TECH BULLETIN

033
05/84

SUBJECT: Crankcase and Rear Cover Change for Models 270, 279, 280, 290

Models 270 & 279

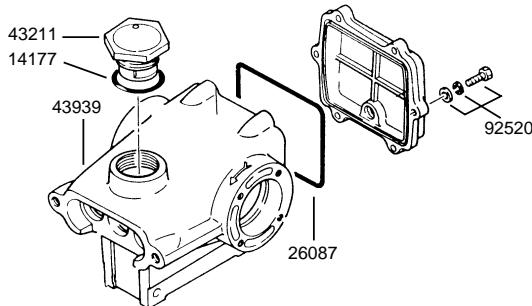
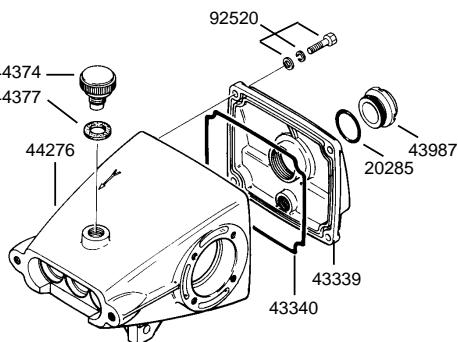
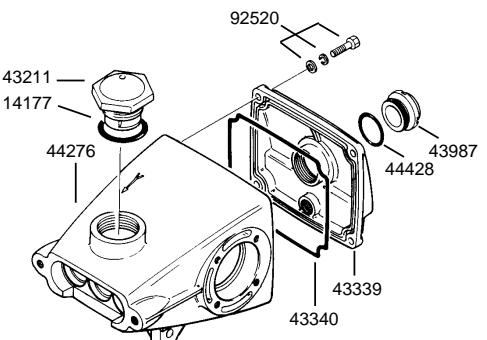
The following is a summary of the crankcase changes which have occurred in the 3 Frame pumps. Due to popular demand, the large oil filler cap has been incorporated back into these pumps. Note the Serial Number of the pump you are servicing to assure the proper parts are ordered.

Before SN 2840101	After	After SN 7850101
Crankcase	43939	44276	44657
Crankcase Cover	43453	43339	43339
Oil Filler Cap	43211	44374	43211
O-Ring, Crankcase Cover	26087	43340	43340
O-Ring, Oil Cap	14177	44377	14177
Bubble Oil Gauge	43987	43987	43987
O-Ring, Bubble Oil Gauge	20285	44428	44428
Dimension Change			
Overall Length.....	260 MM (10.2")	261 MM (10.3")	261 MM (10.3")
Additional Changes which are effective with SN 2840101:			
Inlet Manifold Socket Head Bolt (M10x35)	87927	87931	—
O-Ring, Inlet Adapter	14181	17547	—

Models 280 & 290

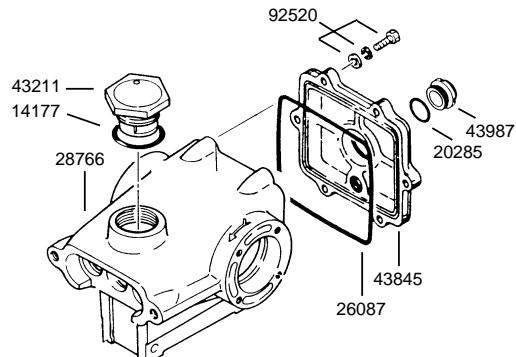
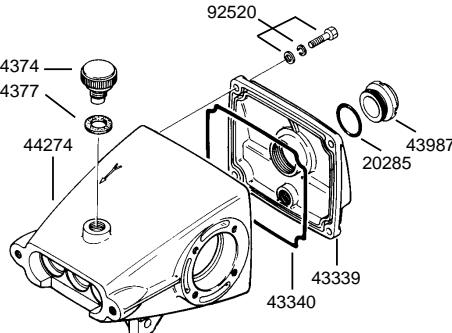
Before SN 3840101	After	After SN 6850101
Crankcase	28766	44274	44658
Crankcase Cover	43845	43339	43339
Oil Filler Cap	43211	44374	43211
O-Ring Crankcase Cover	26087	43340	43340
O-Ring, Oil Cap	14177	44377	14177
Bubble Oil Gauge	43987	43987	43987
O-Ring, Bubble Oil Gauge	20285	44428	44428
Dimension Change			
Overall Length.....	268 MM (10.55")	269 MM (10.59")	269 MM (10.59")
